**DEER CREEK ENERGY LIMITED
JOSLYN NORTH MINE PROJECT**

**JOSLYN NORTH MINE PROJECT
THIRD ROUND EUB SIR RESPONSES**

December 2007

FIGURE 1
PROJECT UPDATE SITE LAYOUT WITH DEVELOPMENT AREA

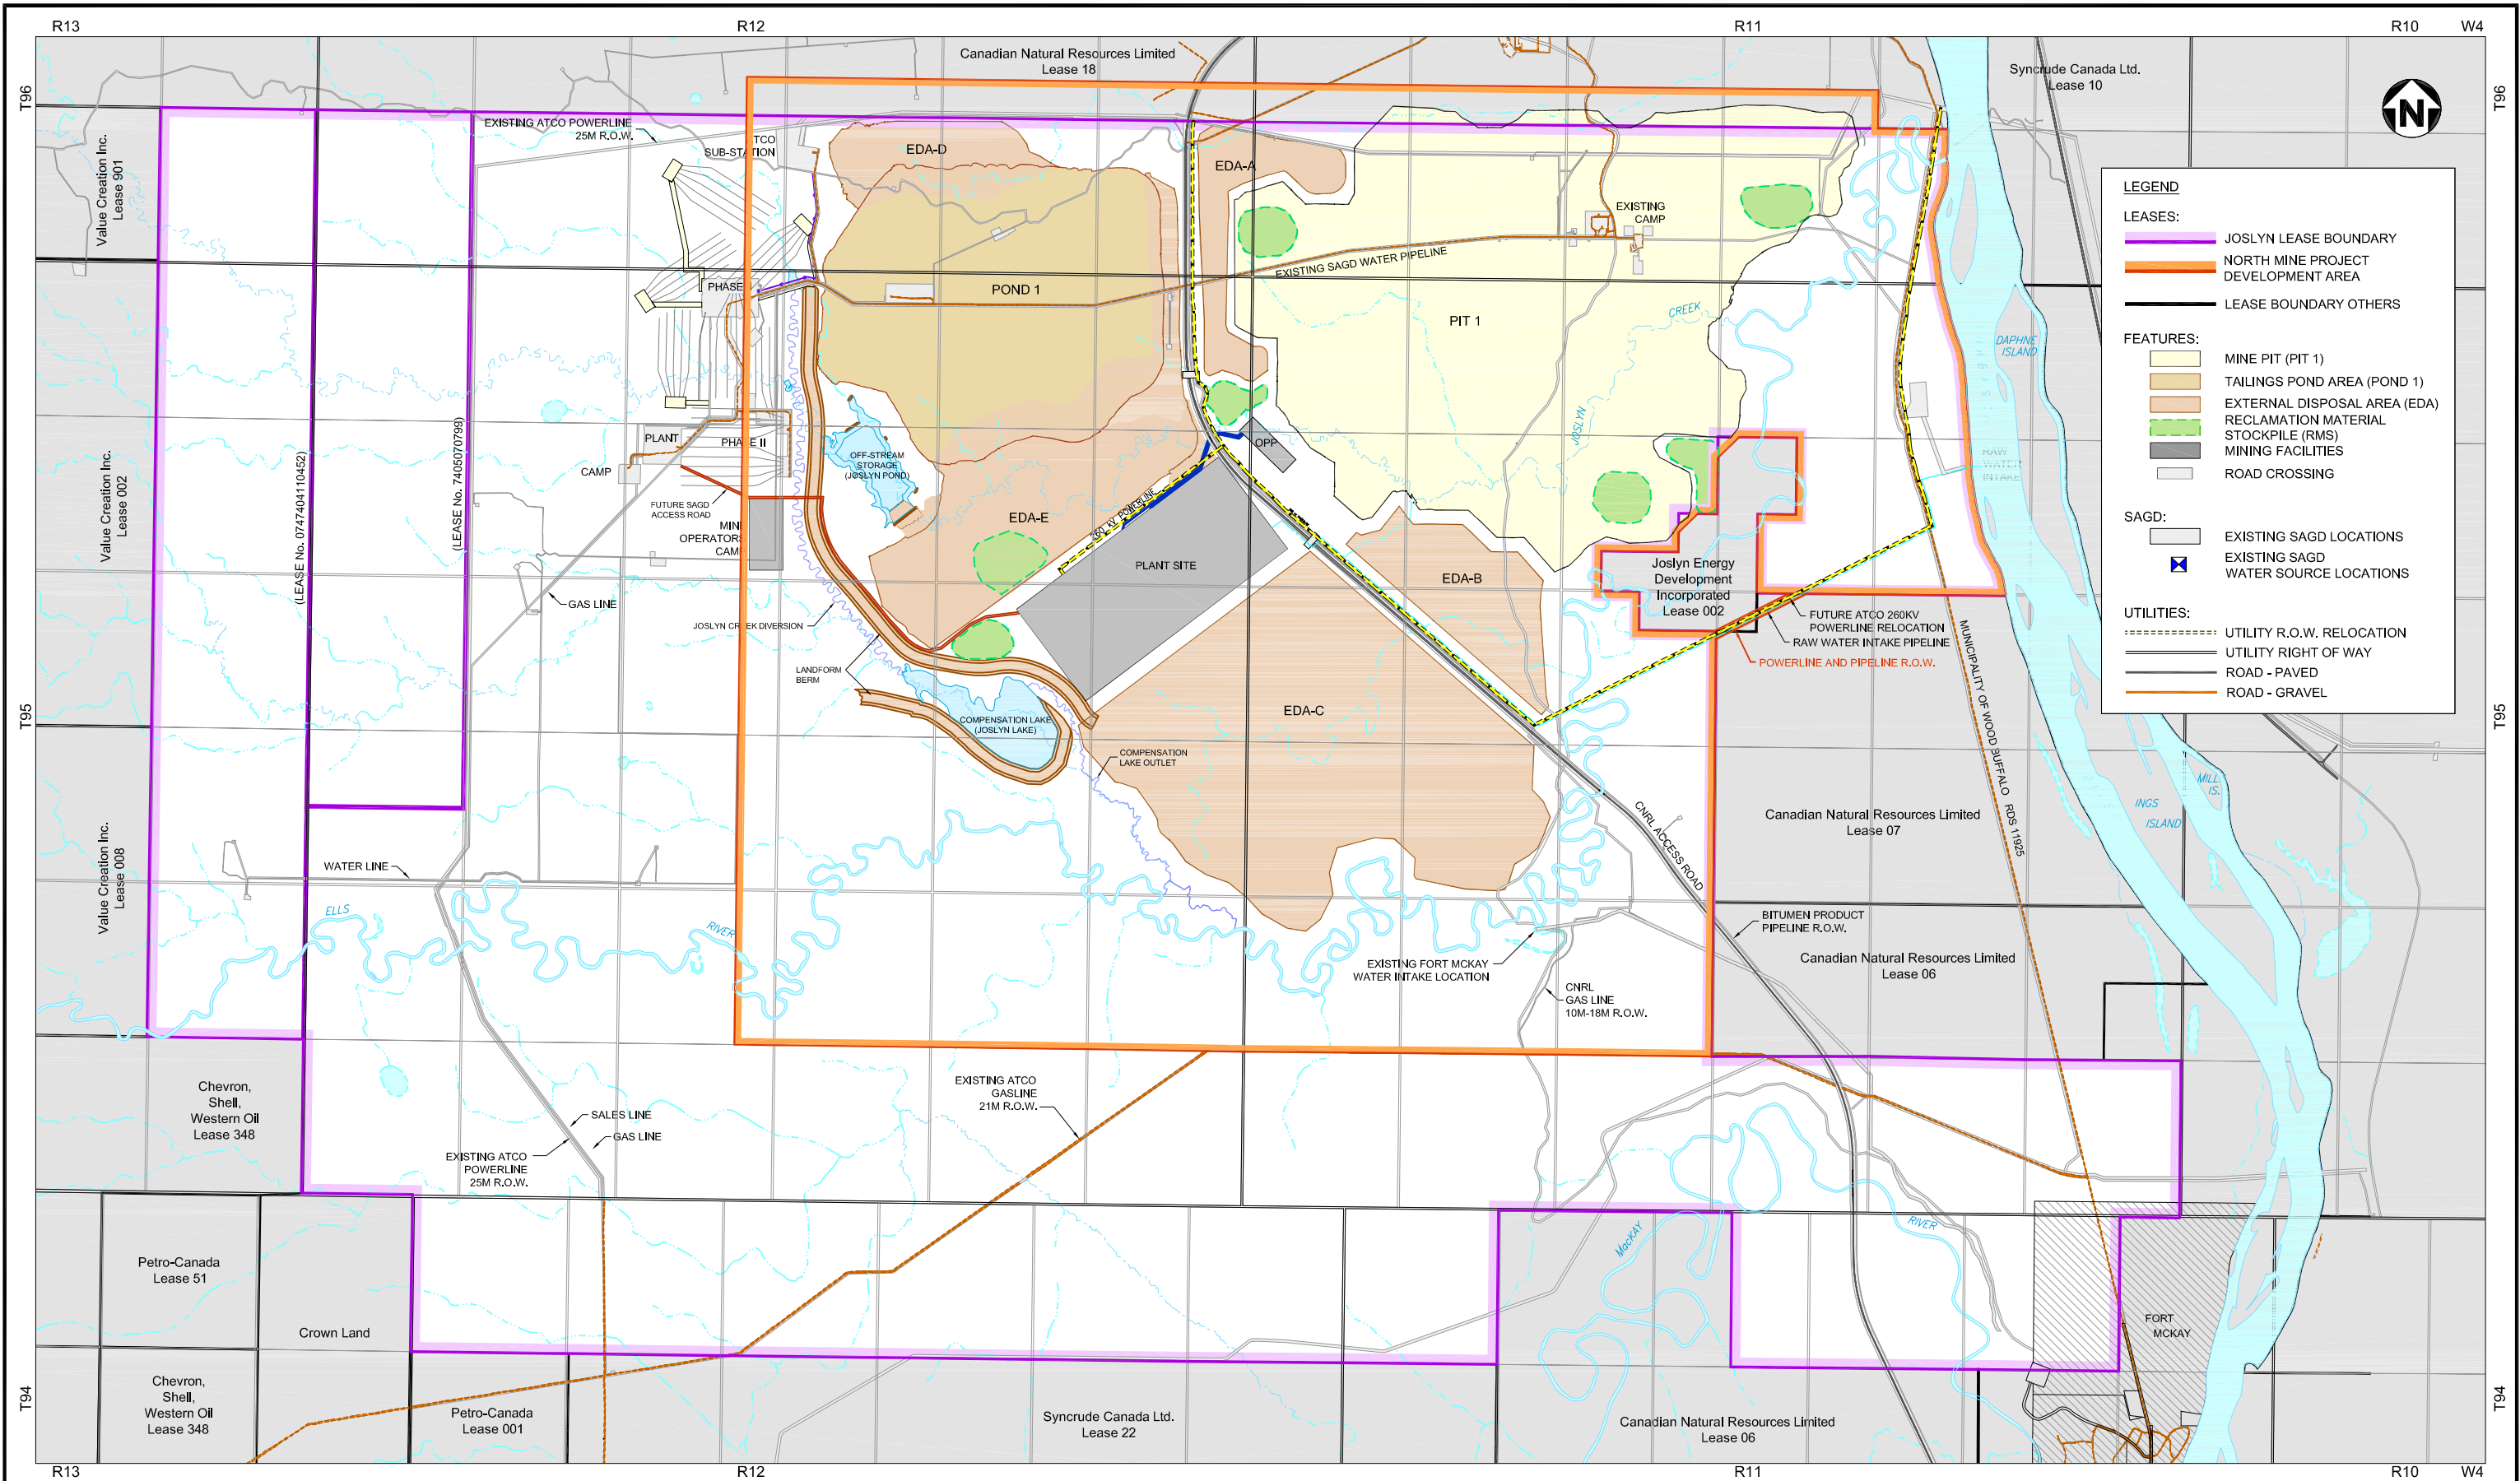
- 1. Provide an updated project map detailing the applied for Joslyn Mine project area structures and major infrastructure.**

For the layout of the proposed project development area (PDA) for the Joslyn North Mine Project, see Figure 1-1. The PDA in Figure 1-1 is similar to the PDA shown in the Joslyn North Mine Application, Figure A.1.0-4. The north boundary is shown slightly north of the Joslyn Lease boundary to reflect a north pit crest that has been extended past the lease boundary for resource conservation purposes. DCEL has engaged with Canadian Natural Resources Limited (CNRL) on boundary planning discussions with the intent to develop a mutually acceptable boundary plan. The PDA in the vicinity of the Joslyn Energy Development Incorporated (JEDI) lease (002) also shows a slight extension on the JEDI lease. DCEL has also engaged with JEDI representatives on boundary planning discussions with the intent to develop a mutually acceptable boundary plan for the Joslyn North Mine Project.

The proposed water intake is indicated in the eastern part of the PDA.

Figure 2-1 Sensitivity of Solids in Product Bitumen to Extent of Asphaltene Precipitation

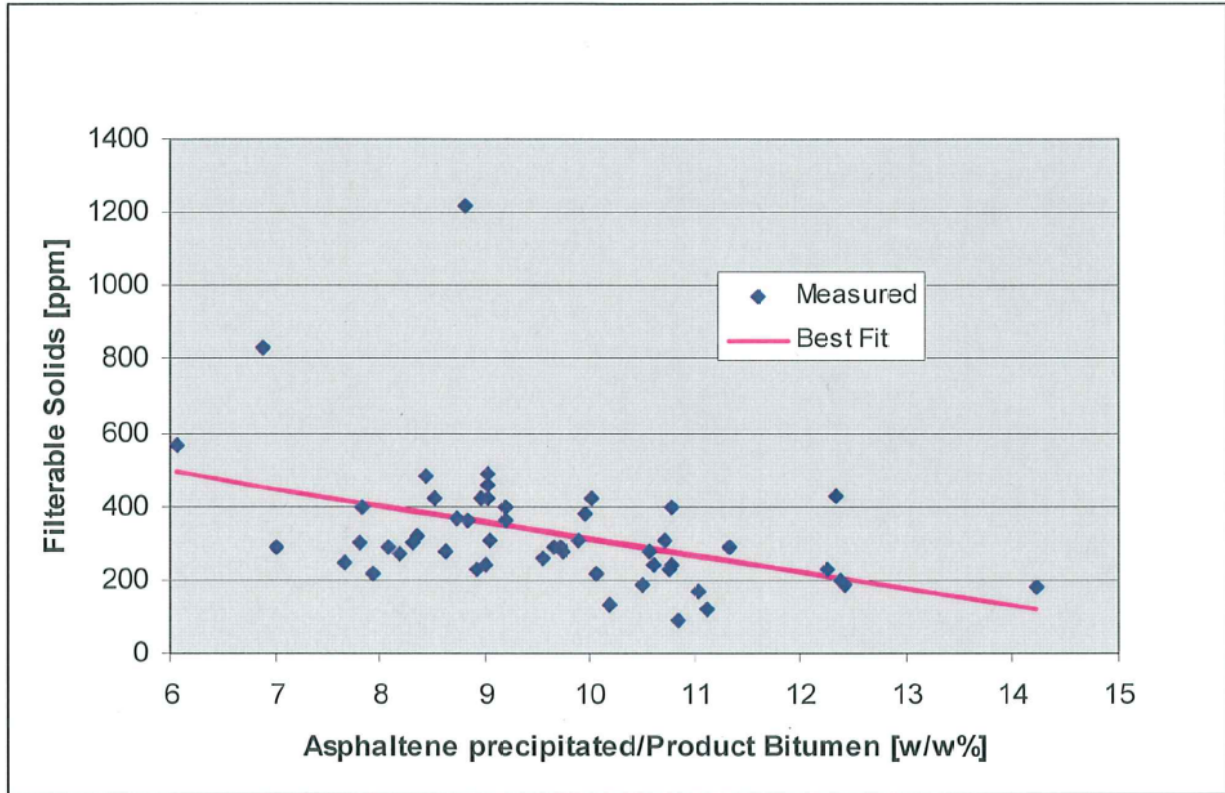
- 2. Secondary SIR Responses, Questions 12c, page 14. Deer Creek Energy Ltd. (DCEL) indicates the imposition of a condition of approval requiring asphaltene rejection not to exceed DCEL's proposed percentage based on bitumen production on an annual average basis would be inappropriate. DCEL also requested an opportunity to further discuss the extent of asphaltene rejection.**
 - a. What asphaltene rejection rates are the mass and energy balances provided as part of the application based upon?**

For DCEL's data relating filterable solids in bitumen product (ASTM D4807) to the quantity of asphaltenes precipitated (n-pentane insolubles), see Figure 2-1. The scatter in the data is partly attributable to analytical accuracy and partly attributable to variations in the first stage settler overflow rate (excessively high overflow rates will entrain more solids for the same extent of asphaltene precipitation).

DCEL’s design basis anticipates the weight of asphaltenes precipitated in the froth treatment process will equal 7.7% of the weight of bitumen product, as shown in the Supplemental Information Submission, Volume 1: Project Update, Figure 5.3-2. The quantity of filterable solids in the bitumen product is a key factor in defining the quality of the product.
